**To:** Safe Roads / NZ Transport Agency  
**Attn:** Liv Theunissen  
**Date:** 2 October 2018  
**Re:** ATP installation issues near SH6 Luggate-Wanaka-Hawea / SH8A Tarras

Quality Assurance Statement	
<i>This document has been prepared for the benefit of New Zealand Transport Agency and Safe Roads Alliance. No liability is accepted by ViaStrada Ltd, or any of its employees or sub-consultants with respect to its use by any other person.</i>	Prepared by: Glen Koorey
	Reviewed by: Axel Wilke
	Project Number: 1090-14
	Project Name: ATP markings cycling review
	Version: 1

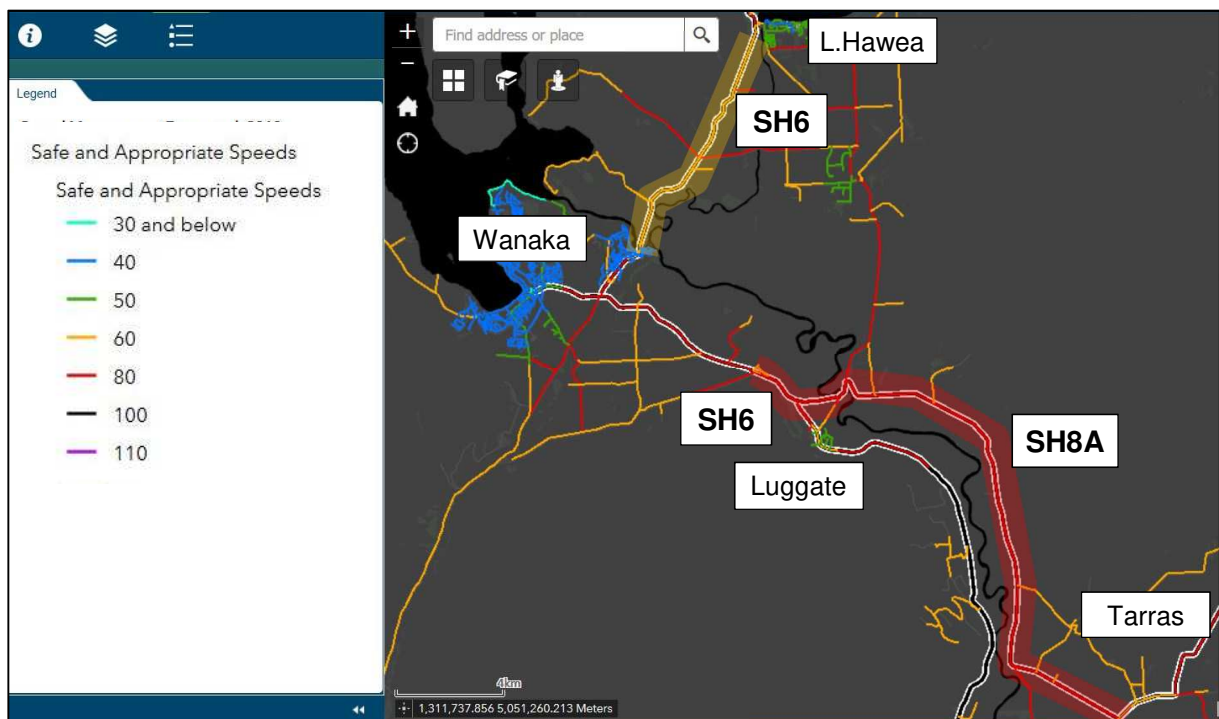
In all cases investigated, **reducing the speed limit** to no more than 80 km/h would be very effective to reduce the likelihood and severity of cycle crashes with motor vehicles. The calculated “safe & appropriate speed” for the roads investigated in this report (from NZTA Risk Assessment maps) is 80 km/h or less (e.g. see extract below).

**Recommended treatment:** *lower speed limits to 80 km/h on sections of concern*
